6 September, 2007

**RE: REVIEW OF OLIN CORPORATION REPORTS: (1) LLAGAS SUBBASIN
CLEANUP WORKPLAN, JUNE 15, 2007; (2) SECOND QUARTER 2007
GROUNDWATER MONITORING REPORT, JULY 30, 2007**

On behalf of the City of Morgan Hill (the City), WorleyParsons Komex has reviewed the Olin Corporation (Olin) June 15, 2007 report, "Llagas Subbasin Cleanup Work Plan" (the Workplan) and the July 30, 2007 report "Second Quarter 2007, Groundwater Monitoring Report" (the Q2 Report) for the Olin property at 425 Tennant Avenue, Morgan Hill, California (the Site), submitted to the Central Coast Regional Water Quality Control Board (RWQCB). For reader convenience, figures from these reports cited in this letter are included in Attachment A.

Piezometer Hydrographs and Municipal Well Operations

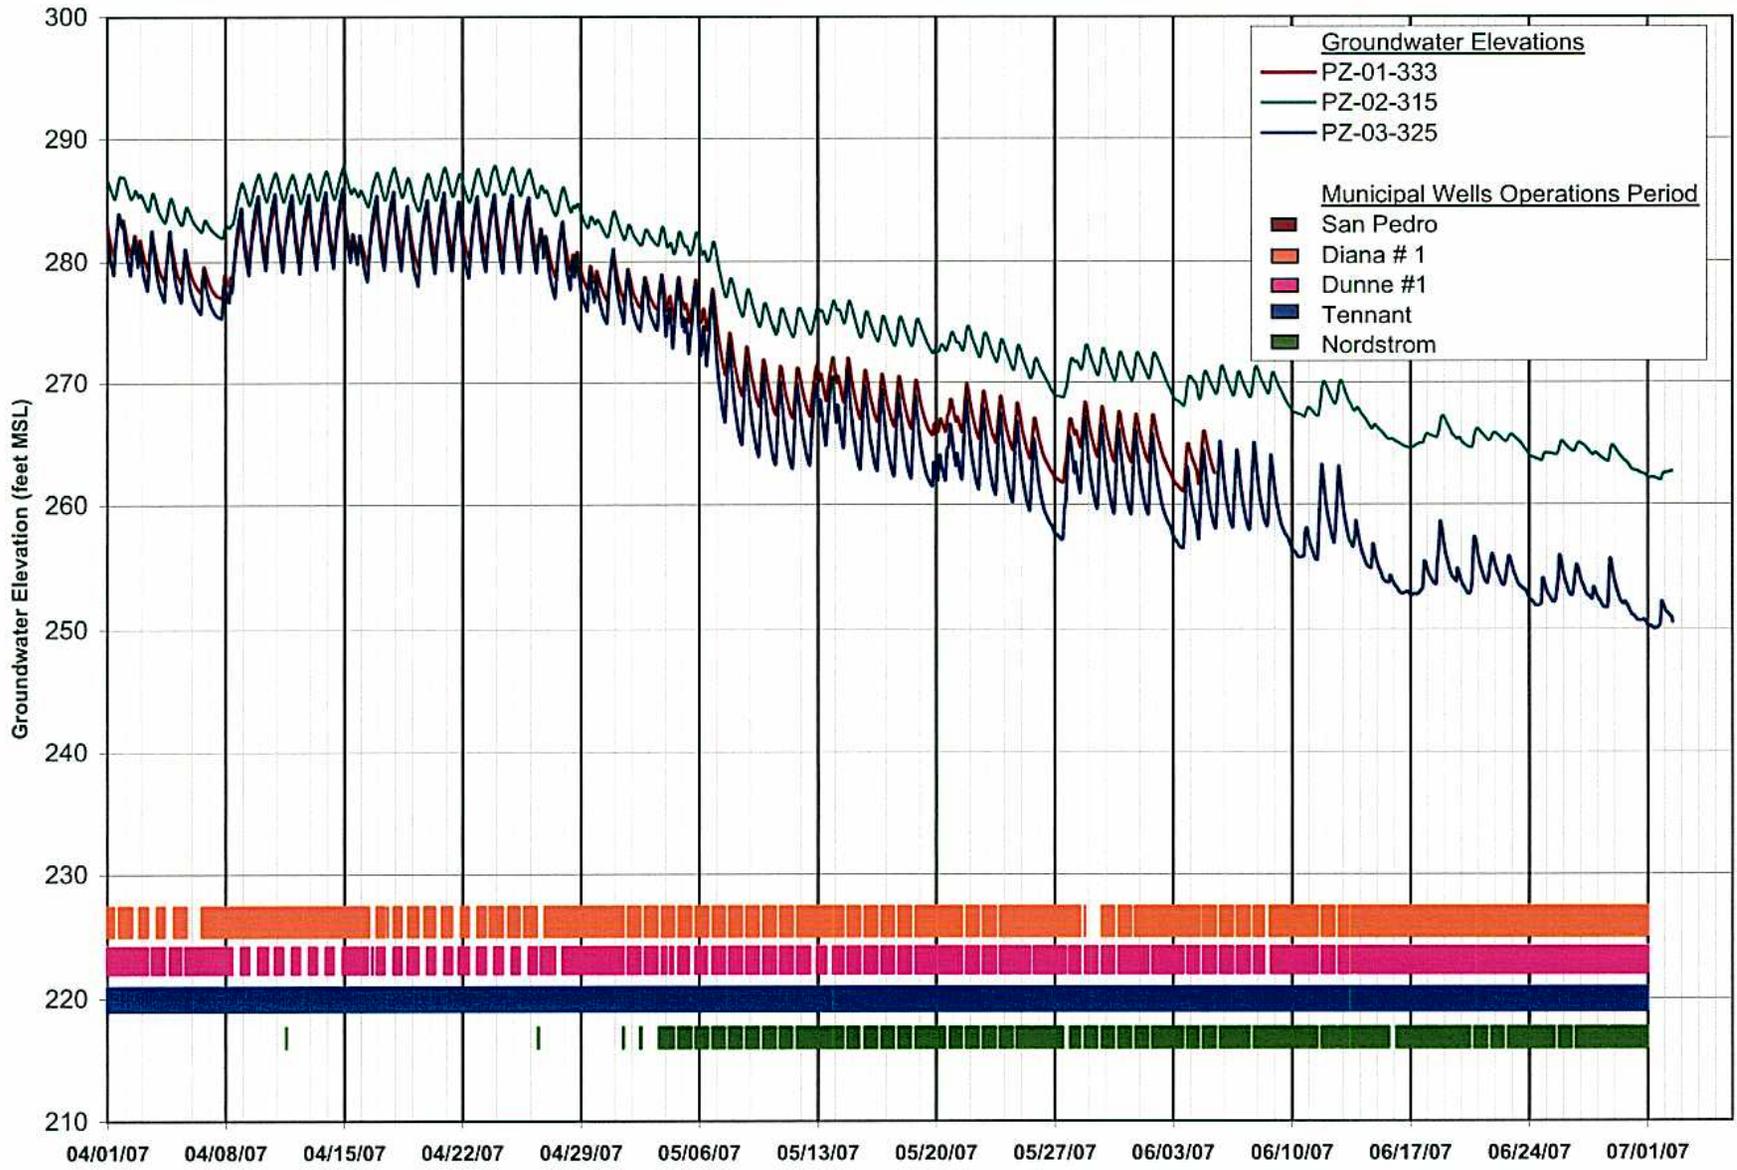
The Q2 Report, like other recent Olin groundwater monitoring reports, does not include a detailed discussion of northeast flow conditions or perchlorate distribution. Northeast flow data are provided in Appendix C, with the exception of Figures 3.20 and 3.21 in the body of the report. Major comments on the Q2 Report are as follows:

Groundwater Flow Direction and Gradients
Middle Deep Aquifer (Second Quarter 2007)
 Second Quarter 2007 Groundwater Monitoring Report
 Olin/Standard Fusee Site
 Morgan Hill, California

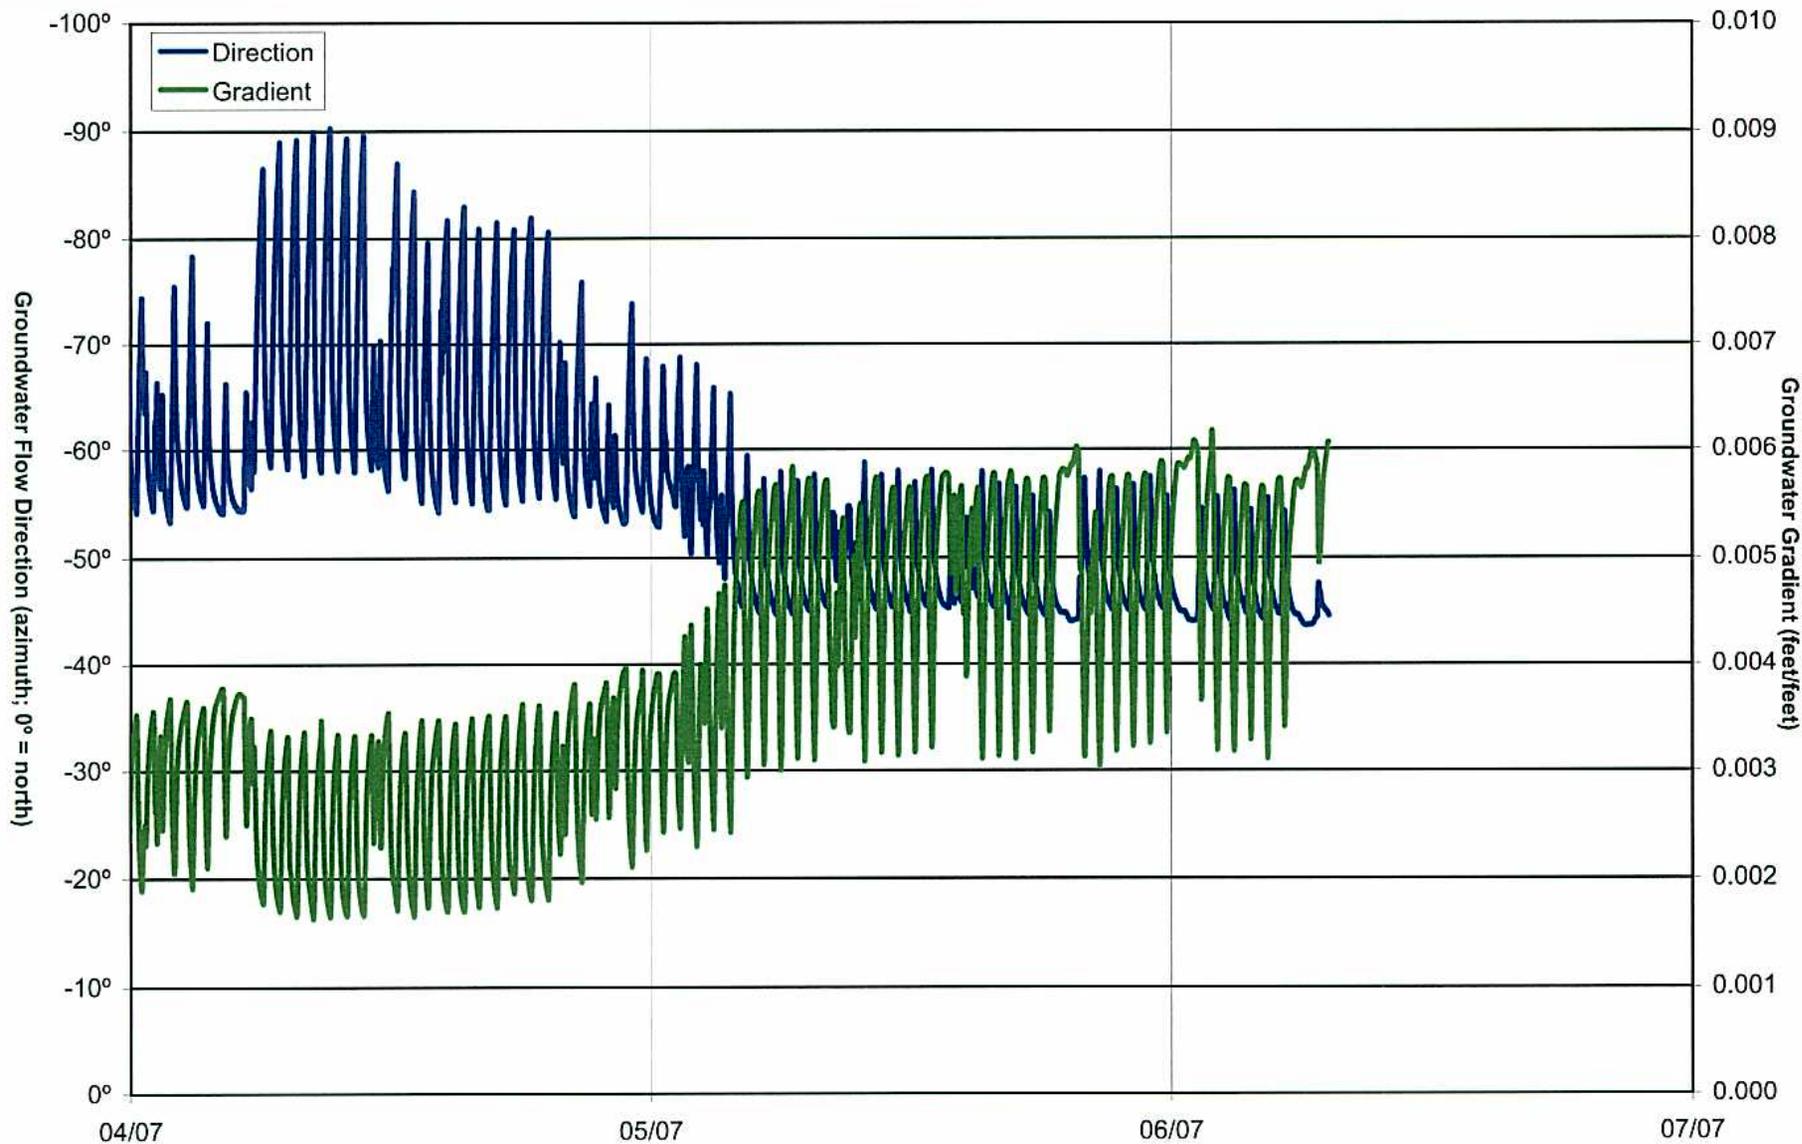
- a) As shown in Q2 Report Figure 3.21, groundwater flow directions between the triad of piezometers PZ-02-315, PZ-01-333 and PZ-03-325 through April 2007, with the Nordstrom well off-line, was northwestward (approximately N55°W) when City wells were pumping, and westward (N70°W to N90°W) when the wells were off, reflecting the typical daily pumping cycle of the City's wells. With the start-up of the Nordstrom Well in early May (approximately May 3) there was an immediate shift in groundwater flow direction of approximately 10 degrees to the north, resulting in a groundwater flow direction of N45°W, which was maintained for the duration of recorded data (to approximately June 19, 2007). As in the previous seven quarters (third quarter 2005 to first quarter 2007), there is no indication of a southerly component to groundwater flow in the Middle Deep Aquifer zone represented by this triad of piezometers.

Spatial Distribution of Concentration Trends
Deep Aquifer
 Second Quarter 2007 Groundwater Monitoring Report
 Olin/Standard Fusee Site
 Morgan Hill, California

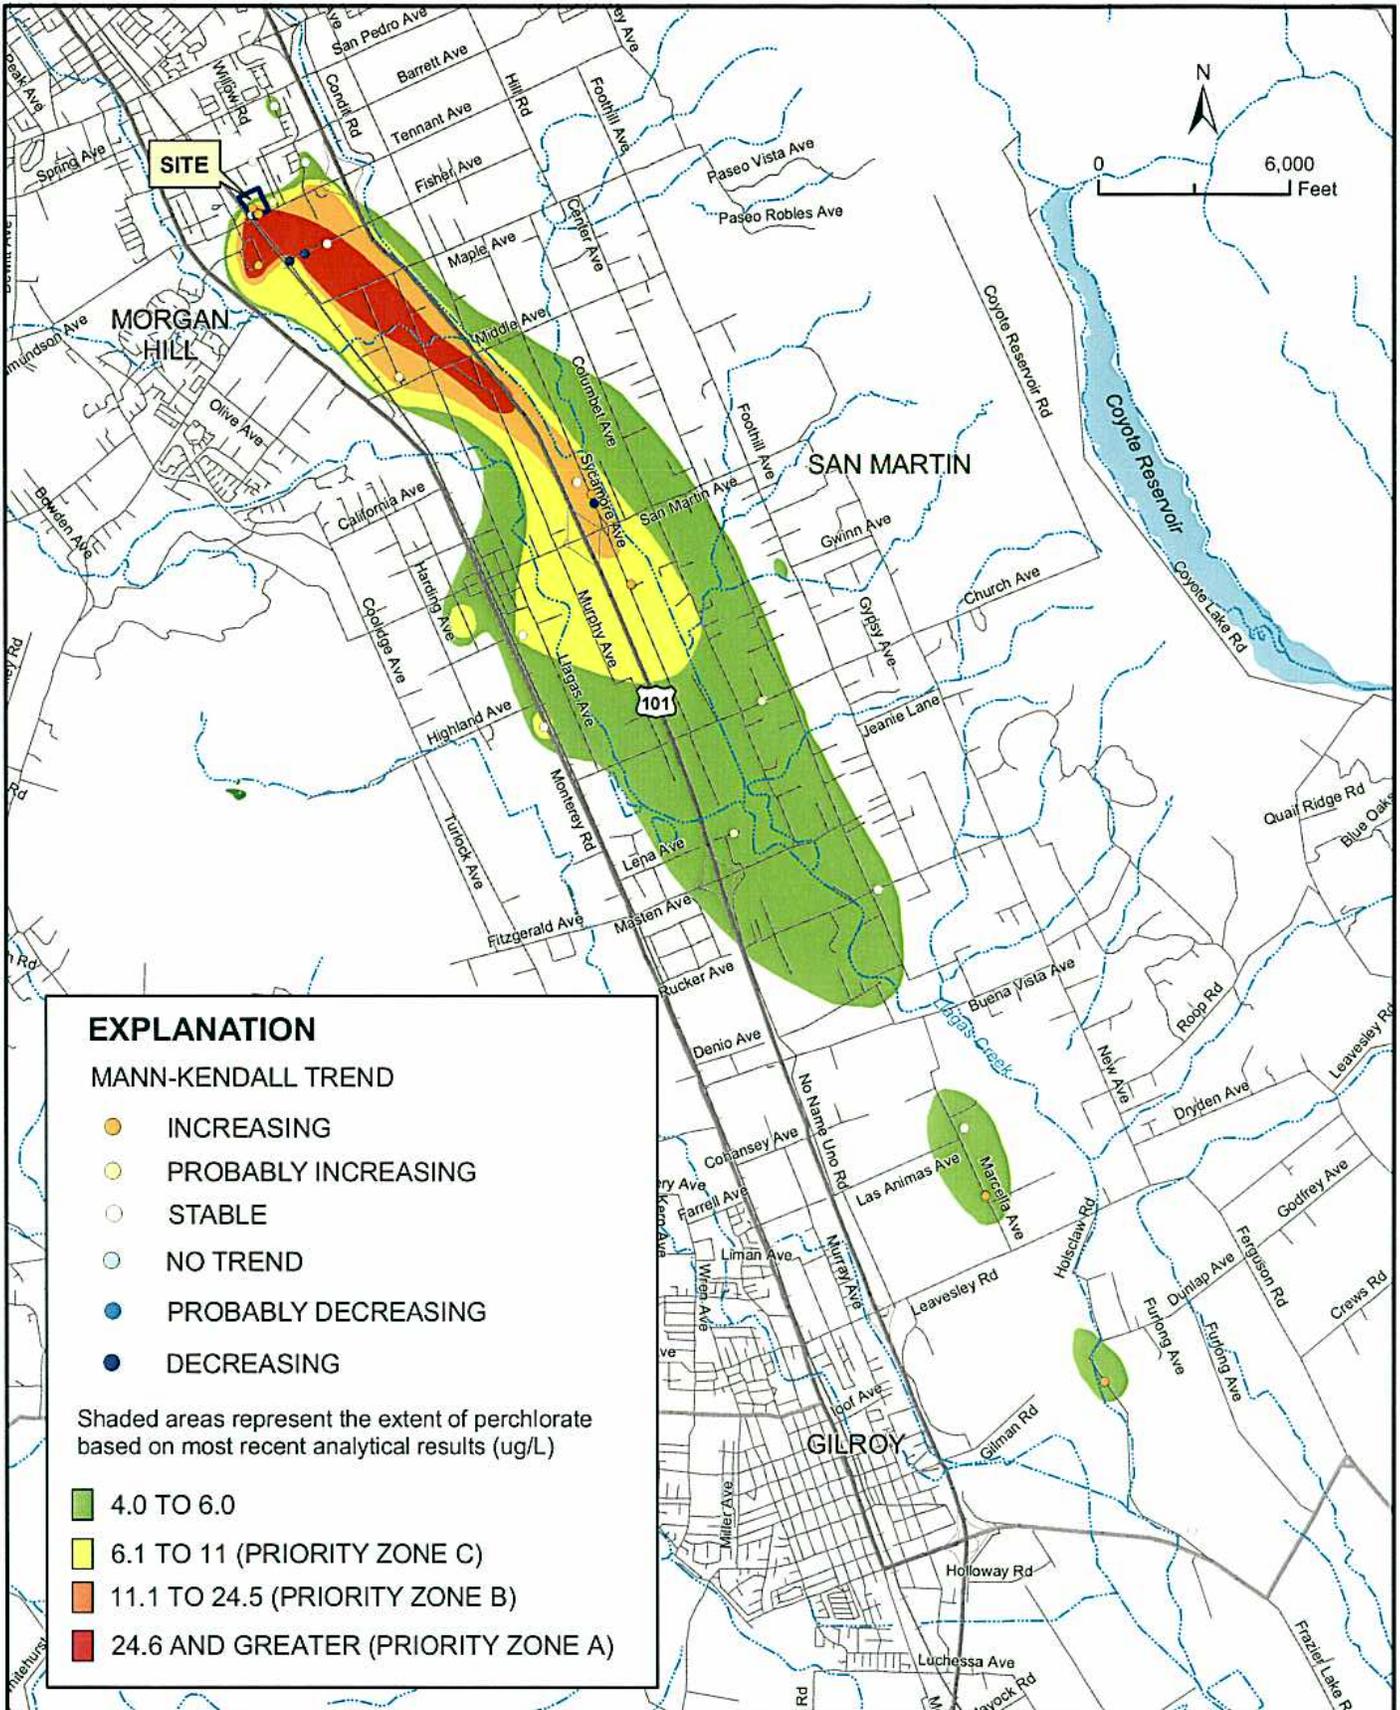
- c) The trend analysis for perchlorate in the Deep Aquifer does not appear to have been thoroughly analyzed by Olin, at least in terms of their mapping of perchlorate trends in the Deep Aquifer shown in Figure 3.27. In the Q2 Report, Olin makes reference to the Mann-Kendall analysis of trend only for domestic wells. There is no reference to the Mann-Kendall analysis for their own monitoring wells. This oversight is not acceptable since reliable data for the Deep Aquifer zone are almost entirely from Olin's monitoring wells, not domestic wells. The mapping of perchlorate trend in the Deep Aquifer (Figure 3.27) does appear to show data points corresponding to selected monitoring wells, however if this is the case, the related trend analysis is completely undocumented in the Q2 Report.

The following 21 monitoring wells meet Olin's criteria for Mann-Kendall analysis (greater than four samples with at least half the results above the reporting limit of 4 ug/L) and yet do not appear to have been plotted by Olin on Figure 3.27 or otherwise discussed by Olin in the Q2 Report (note: in parentheses, number of detections > 4 ug/L / number of samples):
